As there are a lot of projects planned for this property, I appreciate the amount of work and thought that has been put into this application to-date. I predict the Commission will have the following questions as they do not know the history of this lot and the condition of the house as your team does, due to your time spent analyzing the property for this project. Therefore, to help the review go as smoothly as possible, offering the below information will give the Commission a better understanding of the proposal in advance of the meeting, which should allow you and them to jump right into the heart of the discussion.

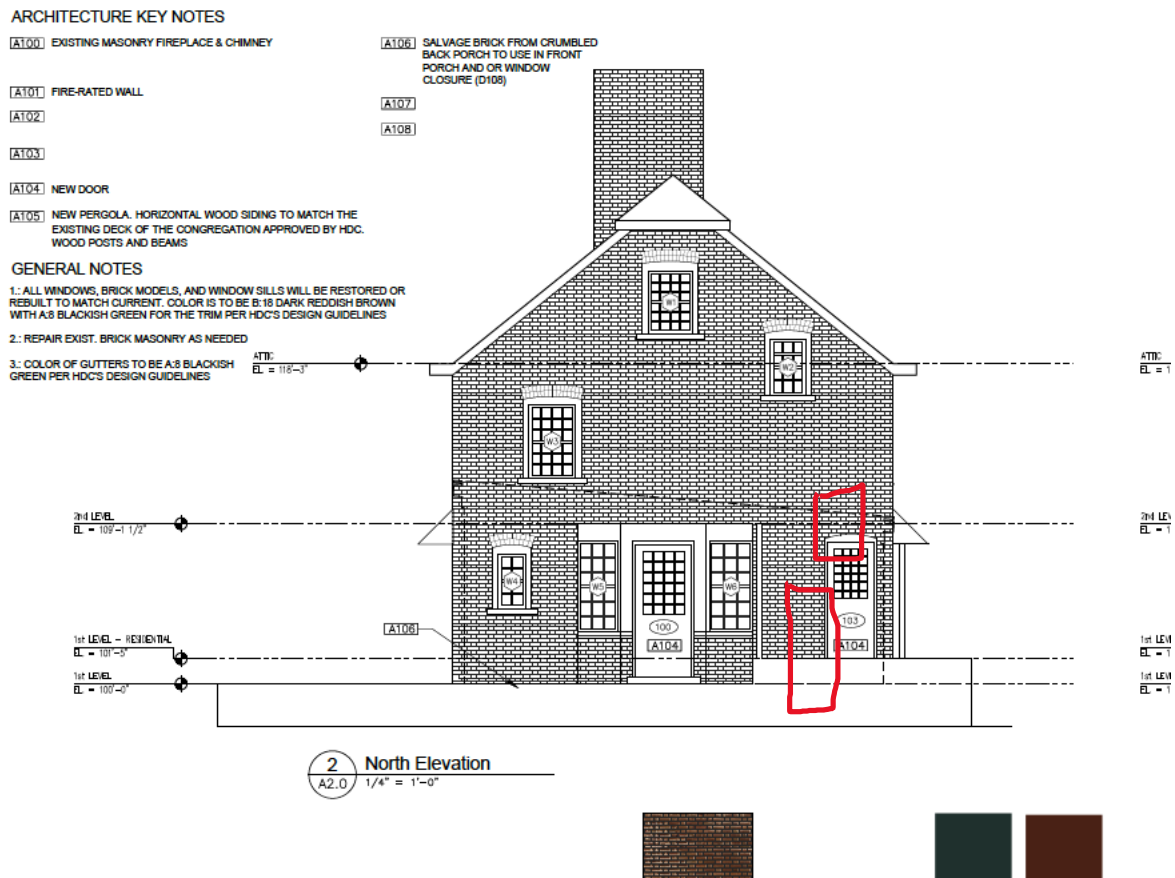
The removal of the existing rear entry and the construction of a new door closer to the NW corner of the house is not listed within the scope of work. Please add this to the project list.

New door sill height. - Does this refer to the door within the bay window, as the patio floor will be higher than the existing porch being removed?

Please see this snapshot from Page 5 of the drawings submitted to you where the window has been bricked in and the door moved higher and farther West. I drew in some redlines where they used to be. Sorry if you have seen this already and you are exclusively referencing the Narrative/Scope of Work.

03: Move Door (D103) higher and further west to accommodate for the New Residential Door Entrance (103) at the back of the building.

The patio/deck height will remain the same. No, this refers to the door (D103), the farthest to the West in the North Elevation where the entry for the upstairs residential tenants will be. Raising the door and the door landing are necessary in order to create a code-compliant stairwell. Please see above.
